CARNEGIE FORUM 305 WEST PINE STREET LODI, CALIFORNIA	<b>AGENDA</b>  <b>LODI</b> <b>SITE PLAN &amp;</b> <b>ARCHITECTURAL</b> <b>REVIEW COMMITTEE</b>	REGULAR SESSION WEDNESDAY, April 24, 2019 @ 5:15 PM
---	---	--

**CITY OF LODI**  
**SITE PLAN AND ARCHITECTURAL REVIEW COMMITTEE**  
**Staff Report**

**APPLICATION NO:** 2019-01 SP

**REQUEST:** **Continued from April 10, 2019** - Request of Site Plan and Architecture Review Committee (SPARC) to consider Site Plan and Architectural Review for a new food and meat commissary with 21,000 sq ft building and food truck and trailer storage at 1365 East Lockeford Street (Applicant: Commissary El Gallo - Conrado and Alberto Marquez; File Number: 2019-06 SP; CEQA Determination: Exempt Per Section 15332)

1 MEZZANINE FLOOR PLAN  
SD.2 3/16" = 1'-0"

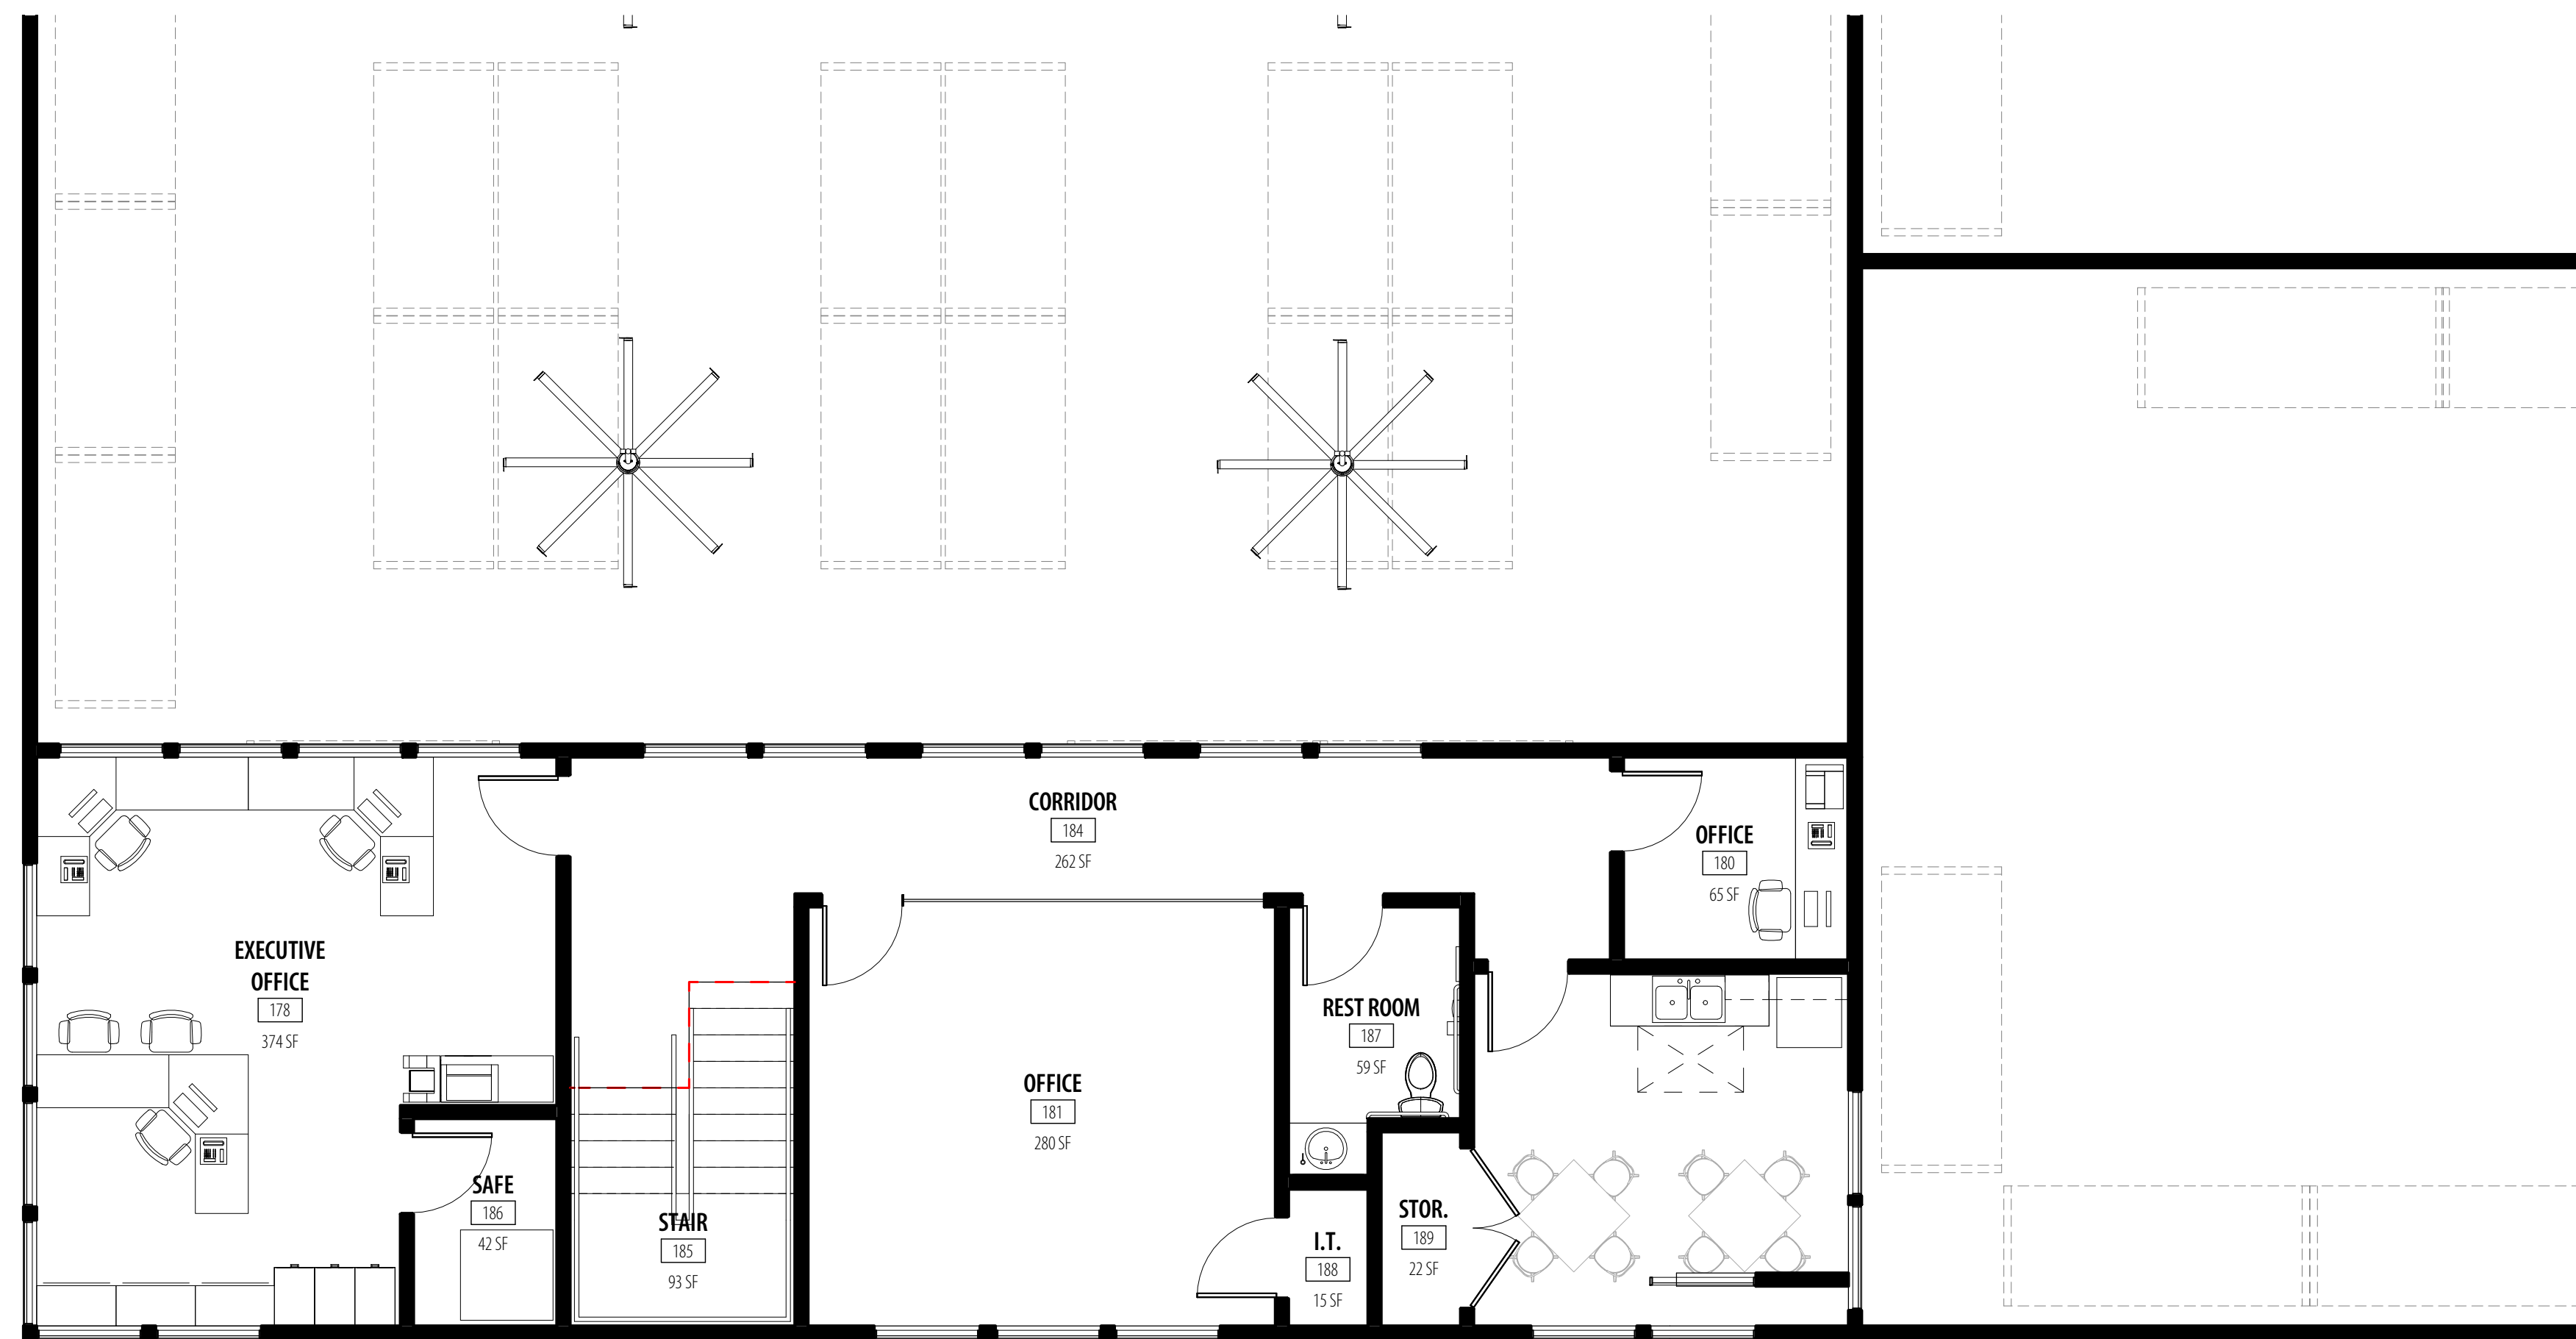
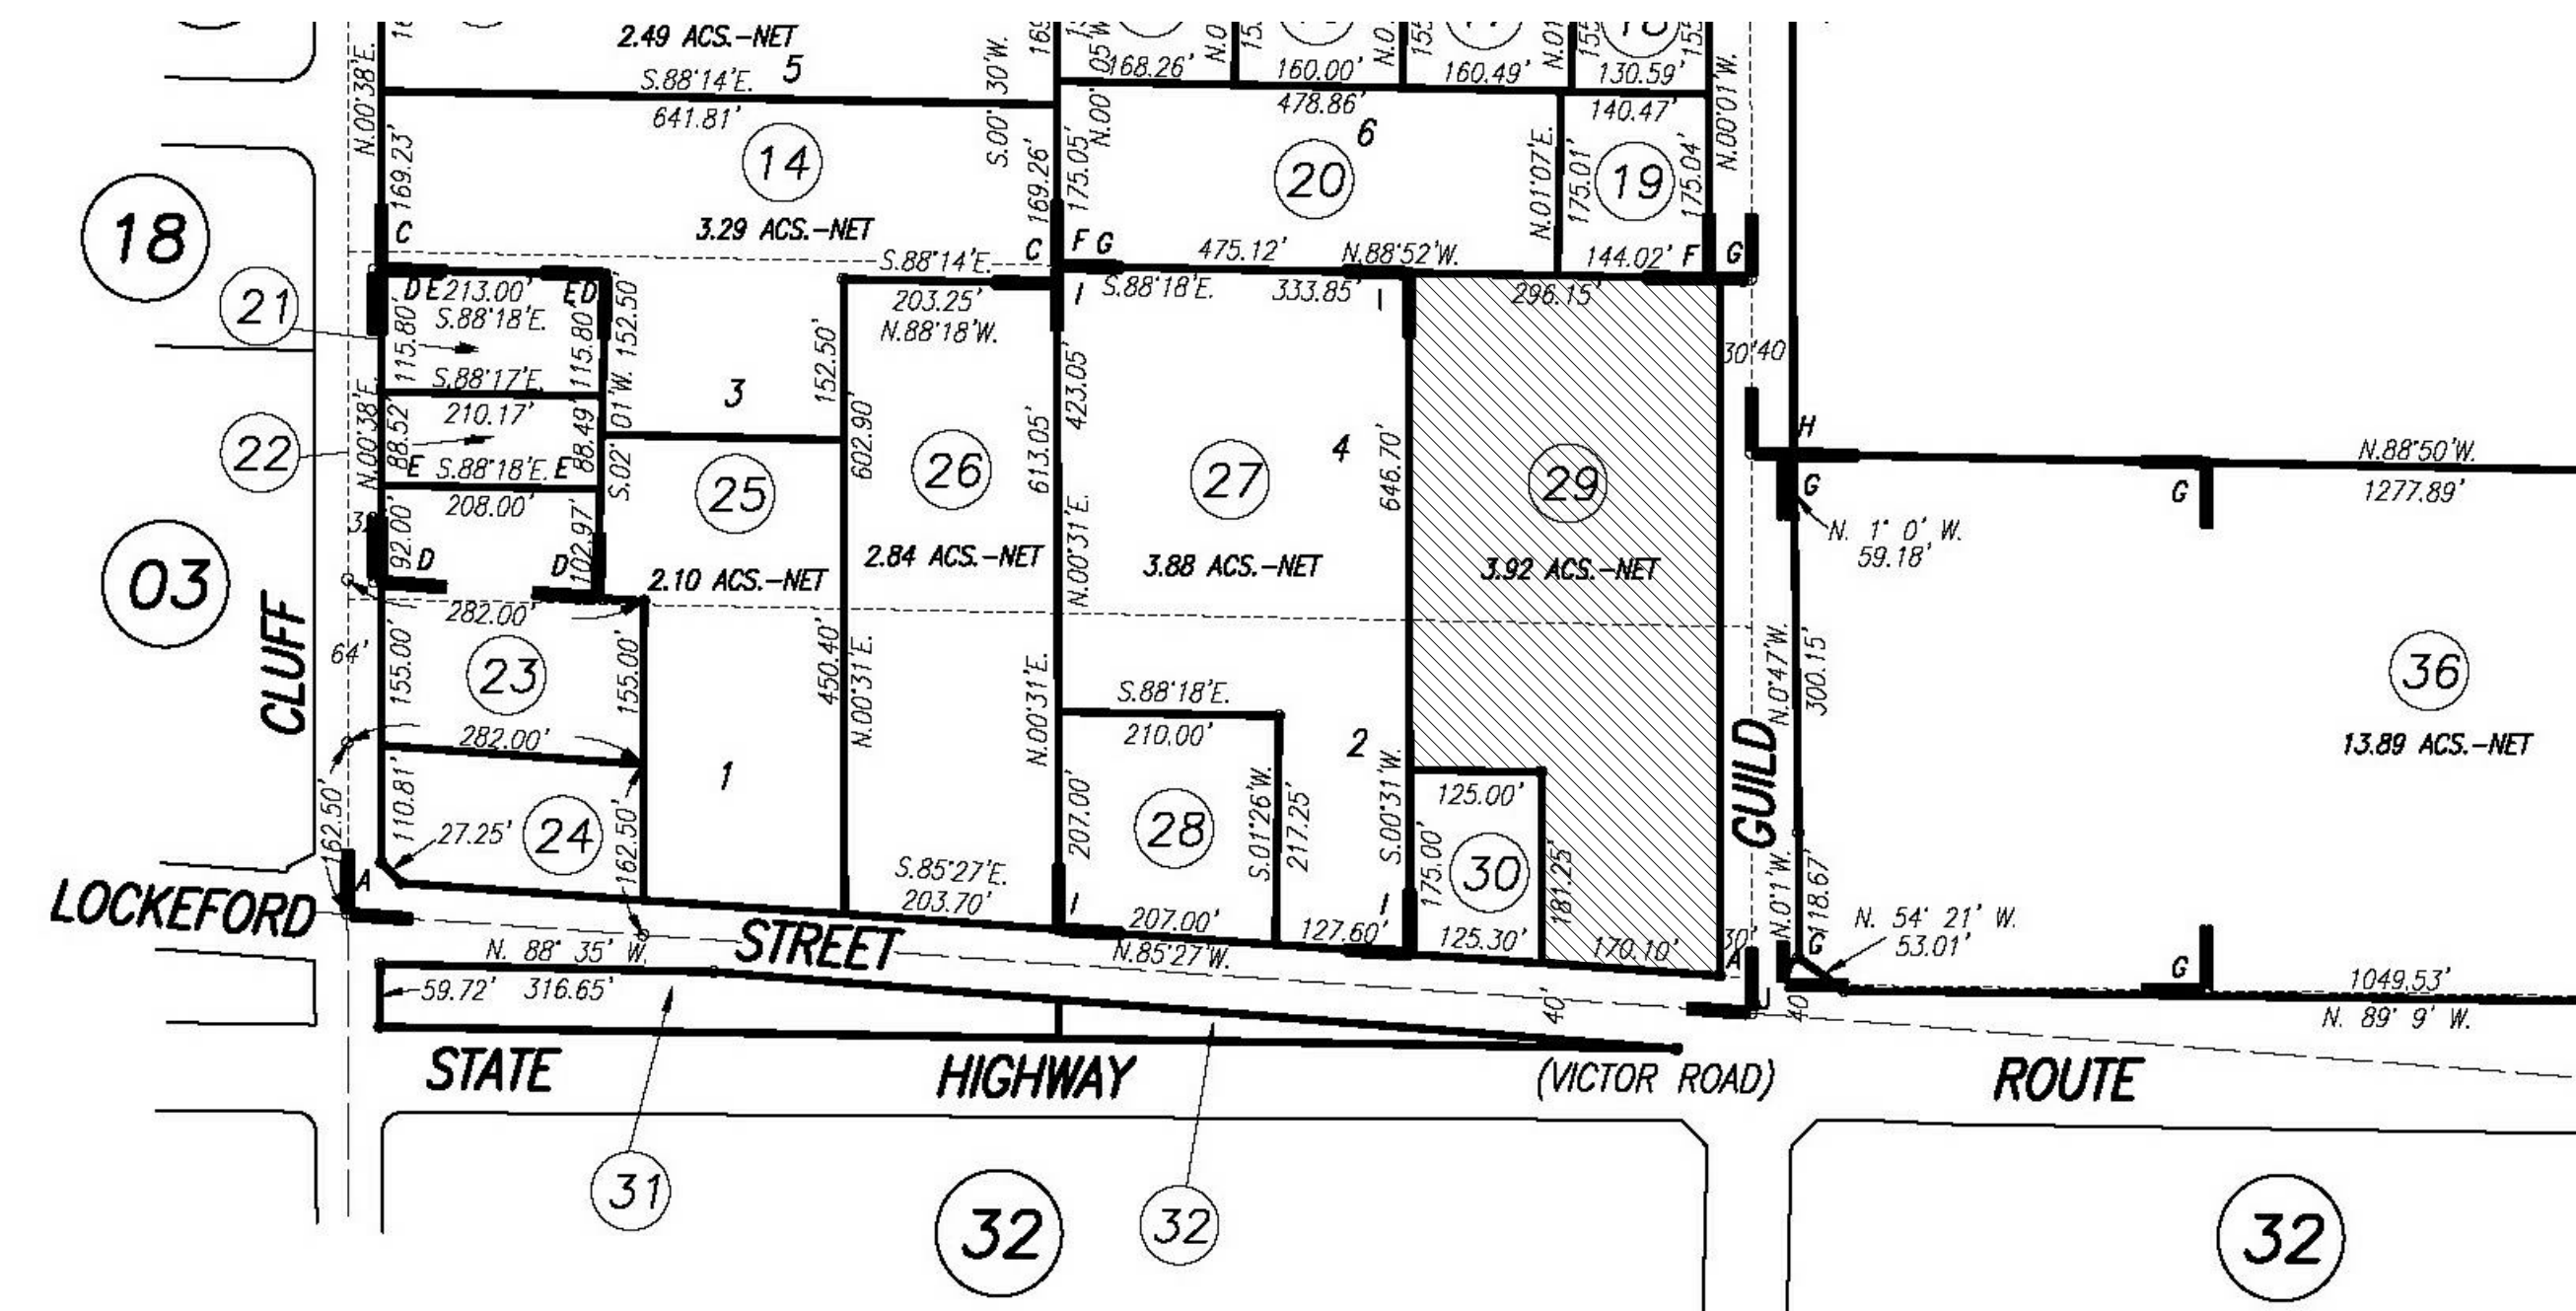
26. Mezzanines are required to be open and unobstructed to the room in which the mezzanine is located. Unless meeting one of the exceptions of the 2016 CBC, Section 505.2.3 the mezzanine appears to be a story [DSA-AC], as defined by 2016 CBC, Section 202.

27. The 2<sup>nd</sup> floor (or mezzanine) contains executive offices, conference room, break room and a USDA office. These facilities are not shown on the ground floor (no equal facilitation). Plans to provide complete and adequate details for elevator or ramp to serve the second floor (mezzanine). 2016 CBC, Section 11B-206.2.3
